**ALERT SERVICE BULLETIN**  
**Bell Helicopter** **TEXTRON**

NO. 230-05-33

**MODEL AFFECTED:** 230

**SUBJECT:** NEW TRANSIENT LIMIT AND POWER TURBINE RPM (NP) STEADY STATE OPERATION AVOIDANCE, INTRODUCTION OF

Figure 2 – Instrument panel

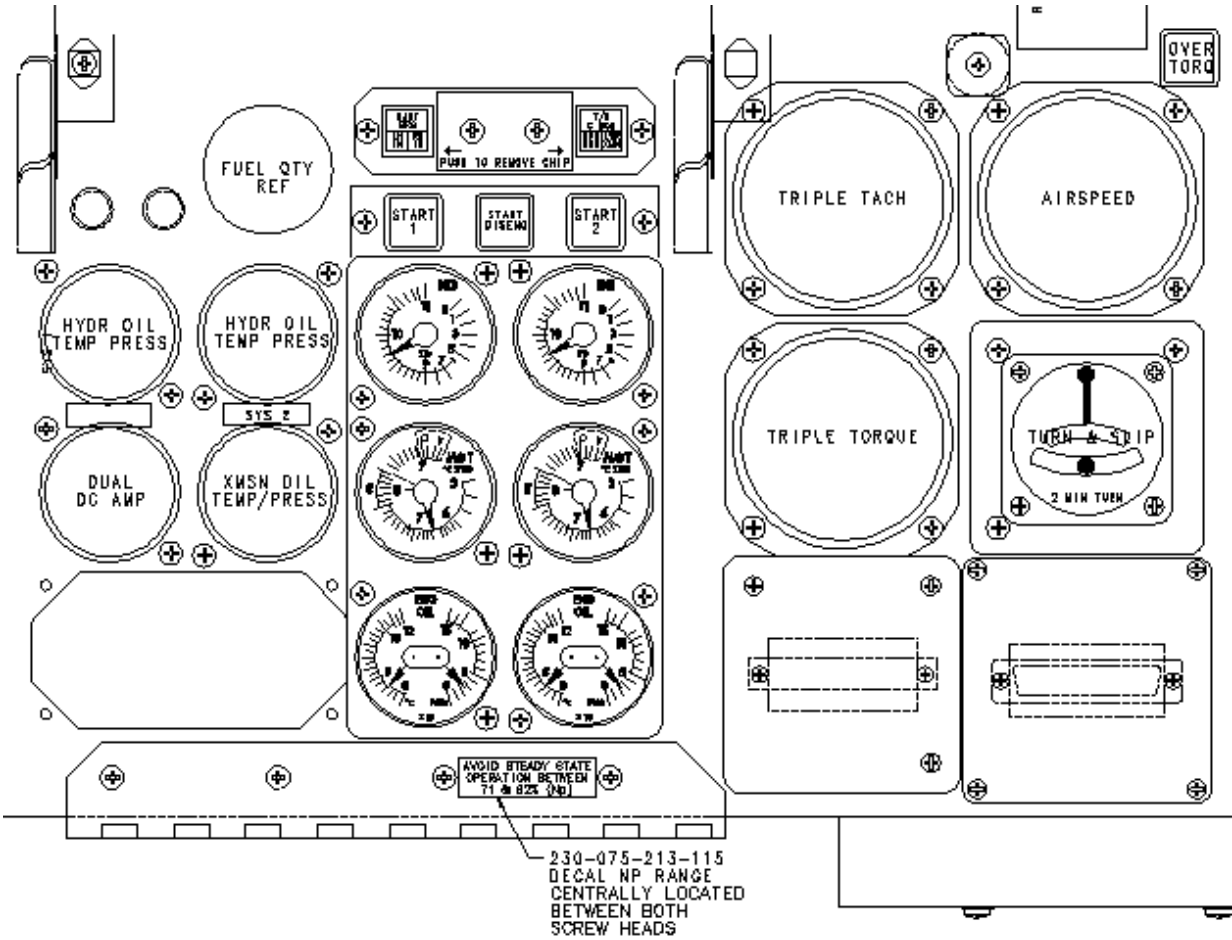
With the release of CEB A-72-3272, Rolls Royce has revised the Model 250-C30G/2 Engine Overspeed Limit Table introducing a new Steady State Operation Avoidance Power Turbine RPM (Np) Speed range between 71% and 92%. A decal is added on the instrument panel to ensure crew awareness of this new Np speed restriction.

1. Comply with Rolls-Royce Corporation ALERT Commercial Engine Bulletin CEB A-72-3272 dated June 13, 2005.
2. Following instructions in BHT-230-MM-2, Chapter 11, install decal 230-075-213-115, as shown in Figure1, on the instrument panel. Refer to Figure 2 for location.
3. Insert the new Flight Manual revision 5 dated May 6, 2005 into BHT-230-FM-1.
4. Annotate the aircraft technical records to indicate that this bulletin is completed.

Power Turbine Speed Restrictions  
FIG. 1

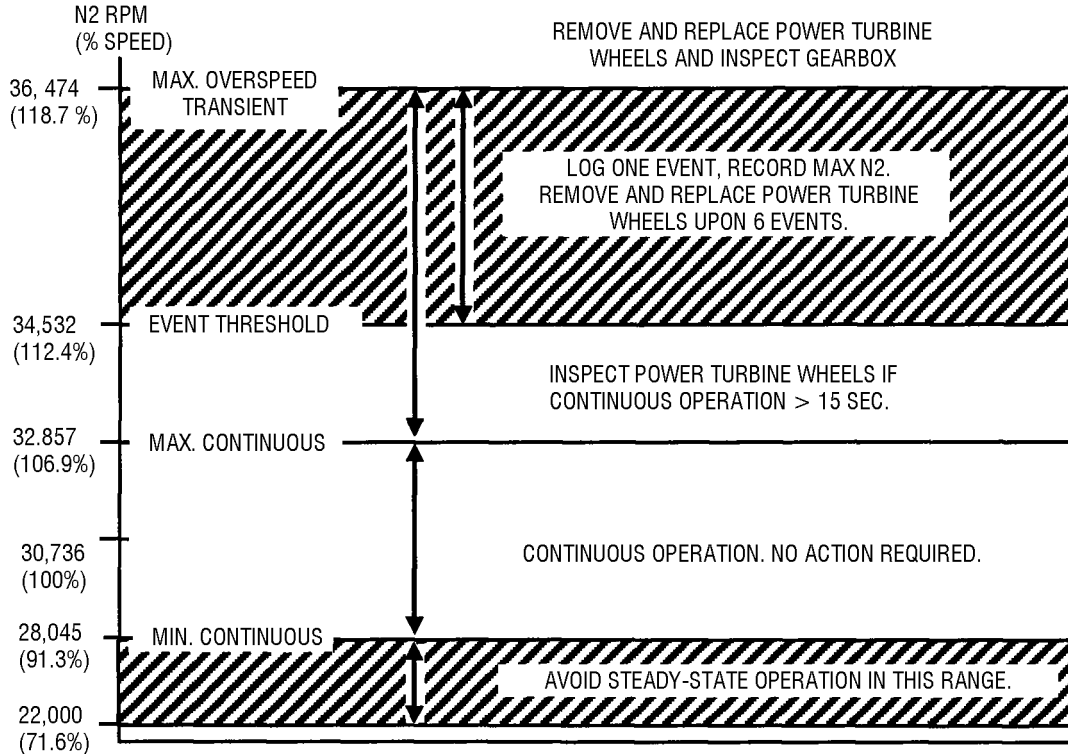
- (1) Transient overspeed excursions between the Max. Continuous line and the Max. Overspeed Transient line, which exceed 15 seconds require specific action as described in this CEB. Any excursion greater than 15 seconds requires power turbine wheel inspection.

- (2) The transient overspeed range is now divided into two sections. Any transient overspeed excursion above the Max. Continuous line and below the new Event Threshold line does not require maintenance action provided the single event is less than 15 seconds.

- (3) Any transient overspeed excursion above the new Event Threshold line and below the Max. Overspeed Transient line does not require maintenance action provided the single event is less than 15 seconds; however, the excursion shall be recorded as an event. No more than five events are allowed in this new range.

- (a) Maintain Engine Log Book Records so that transient N2 speed excursion events into the new range between 34,532 RPM (112.7% for the C30, C30G, C30M, C30P, C30R, C30R/1, C30R/3, C30R/3M, C30S, C30U and C47M; 112.4% for the C30G/2; 107.3% for the C47B; and 111.7% for the C40B) and 36,474 RPM (119.0% for the C30, C30G, C30M, C30P, C30R, C30R/1, C30R/3, C30R/3M, C30S, C30U, and C47M; 118.7% for the C30G/2; 113.3% for the C47B; and 118.0% for the C40B) are recorded. Record the maximum speed exceedance value and the date in the Life Limited Part Log Card.

- (b) Only five total events are allowed into this range. The sixth event into this range requires removal and replacement of the power turbine wheels.
